Planned Residential Development Staff Report and Recommendation

Community Development Department, Planning Division

FILE NUMBER: 311-22-000027-PLNG

FILE NAME: Ritchey Ridge Planned Development and Subdivision

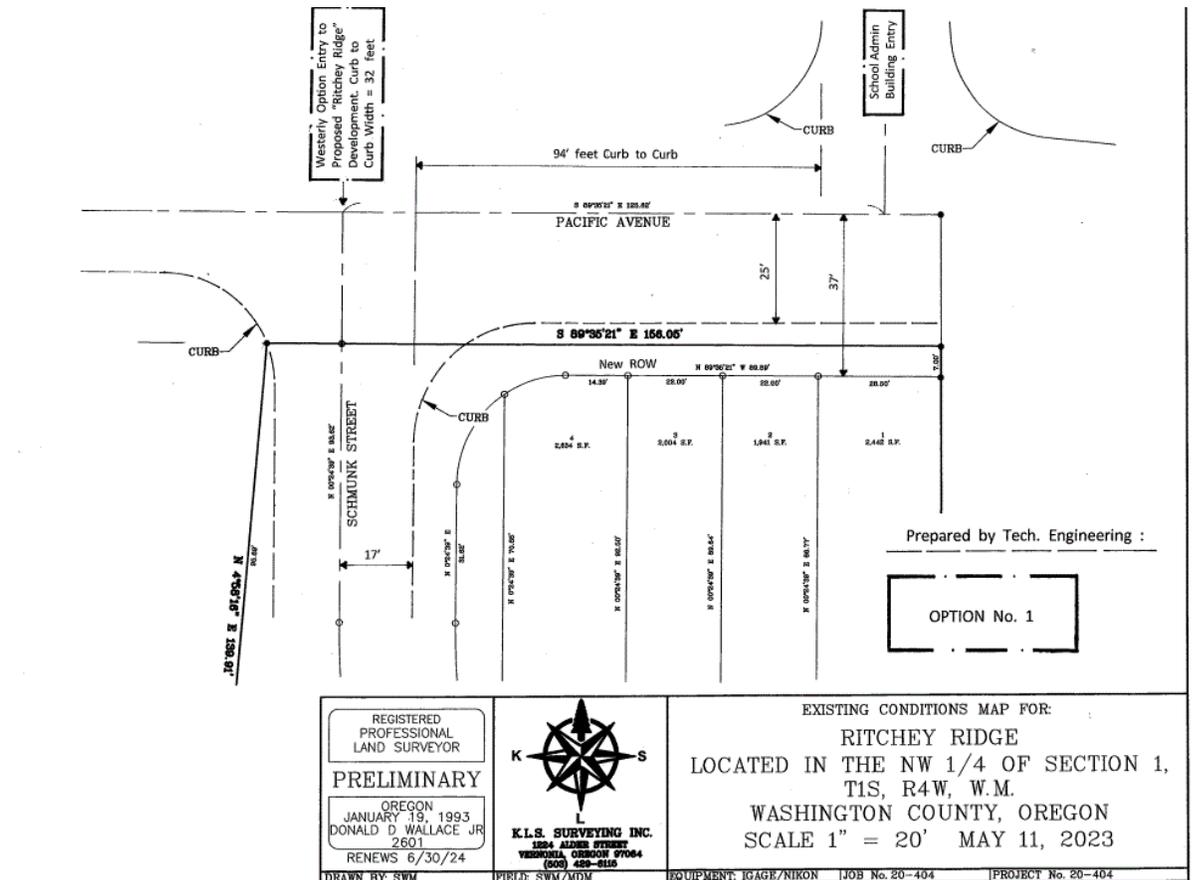
The traffic analysis indicates studied street intersections will operate acceptably during the afternoon peak hour (worst case scenario) with the proposed development upon completion and at build out. The analysis concludes that no mitigations are necessary or recommended with development of the site. There's no additional information in the record that suggests traffic mitigation is needed.

The traffic study recommends the applicant must work with City staff to limit parking along the south frontage of Pacific Avenue at the new access street in order to maintain maximum line of sight in both directions of travel. The study goes on to state any vegetation, landscaping, and sign monument placement must be reviewed and approved by City staff. This is a proposed condition of approval.

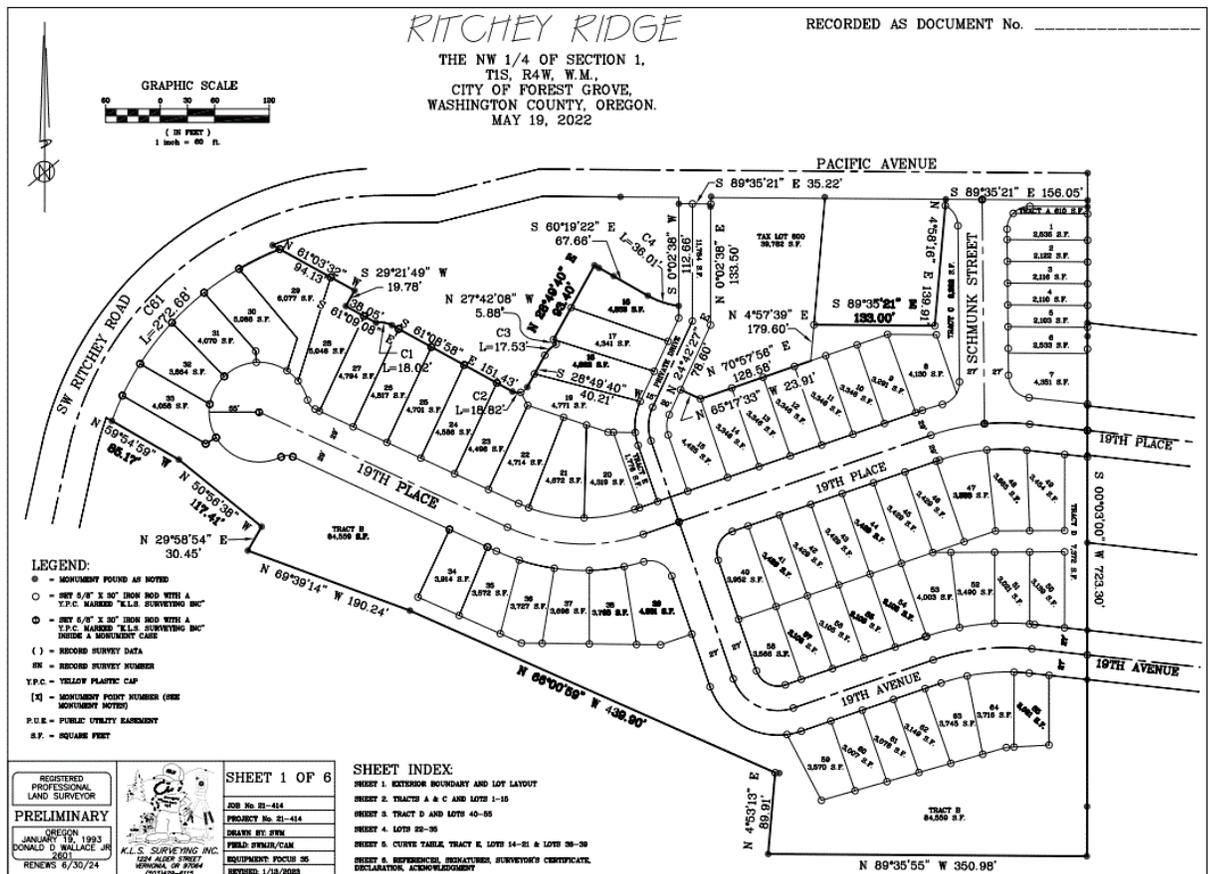
The applicant has proposed a public street approximately 94 feet from the private access that serves the property directly across Pacific Avenue from the development site (Washington County Tax Lot 1N4360002100). The proposed street connection does not meet Washington County access standards because the proposed use is not permitted direct access to a collector and the public street does not meet 100 feet of spacing from other access points. Pursuant to the Washington County Road Design and Construction Standards, an access that does not meet the access standards shall submit a design exception as required by Section 220. Therefore, the applicant will be required to obtain

City staff is supportive of the location and design of the proposed public street connection noted as Option 1 below. This is because the public street connection provides an alternative and direct way in and out of the development without having to travel through the Gales Creek development to access High Street to the east.

In addition to the required design exception, Washington County has requested that the applicant note on the final plan the following:

- Obtain a Washington County facility Permit for the public improvements on Ritchey Road and Pacific Avenue;
- Construct a half-street improvement to Washington County collector (3 lanes) standards pre the direction of the County engineer along the frontage of Pacific Avenue and Ritchey Road. The half-street shall include collector pavement width, bike lane, curb/gutter, 5-foot sidewalk, 6-foot planter strip with street trees and conduit per County standards;
- Installation of continuous street lighting along the site's frontage of Ritchey Road and Pacific Avenue to Washington County standards;
- Closure of all existing driveways/access on Ritchey Road and Pacific Avenue;
- Construction of an emergency access on Pacific Avenue per County/Fire District requirements;
- Provide a preliminary sight distance certification for the site's new public street on Pacific Avenue;

- Provision of a non-access restriction along the site's frontage Ritchey Road and Pacific Avenue;
- Dedication of right-of-way to meet 37 feet from the centerline of Ritchey Road and Pacific Avenue and adequate corner radius at the intersection with the new public street/Pacific Avenue; and
- Dedication of an 8-foot public utility easement along the site's frontage of Ritchey Road and Pacific Avenue.

I. PUBLIC TRAIL:

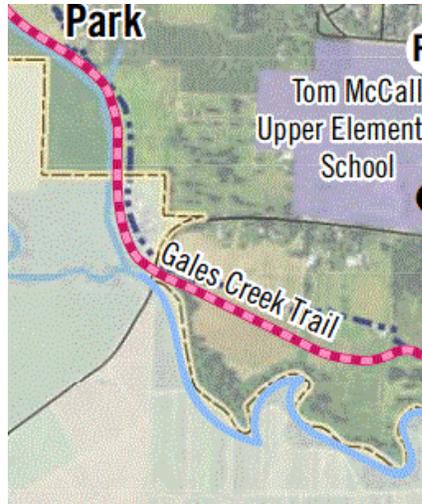
The Parks and Recreation Master Plan, adopted by City Council, in 2016 shows a future multi-purpose trail along the urban growth boundary adjacent to the development site. The trail would extend from the Gales Creek Terrace development along the southern periphery of the development site to Ritchey Road. The applicant has agreed to work with the City's Parks and Recreation Department Director on the siting and constructing the trail.

As a condition of approval an easement shall be provided for construction of trail on Tract E. The final plat shall include a note that Tract E is subject to a public access trail easement, over its entirety. The final plat shall include a note that Grant a public access easement over Tract E for future construction of the trail described in the Parks and Recreation Master Plan. The trail easement shall be designed and improved consistent with the requirements of Development Code §17.8.100 (Access and Circulation).

J. FARM ACCESS:

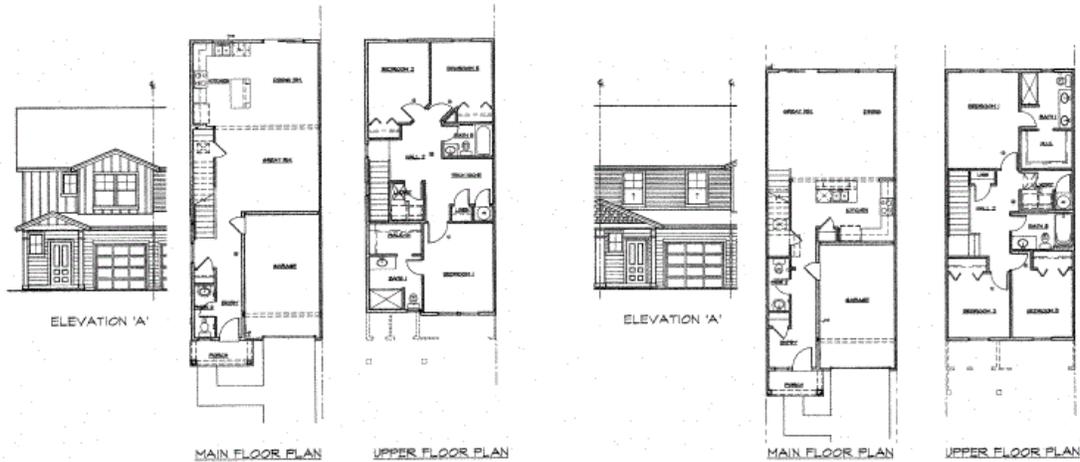
The application indicates there's an existing farm access driveway at the southeast corner of the site which will remain and will be utilized as maintenance access to a water quality facility. As required by the Development Code (§17.8.125(A)(1) service drives for non-residential uses shall be fully improved with hard surface pavement with a minimum width of fifteen feet when accommodating one way traffic.
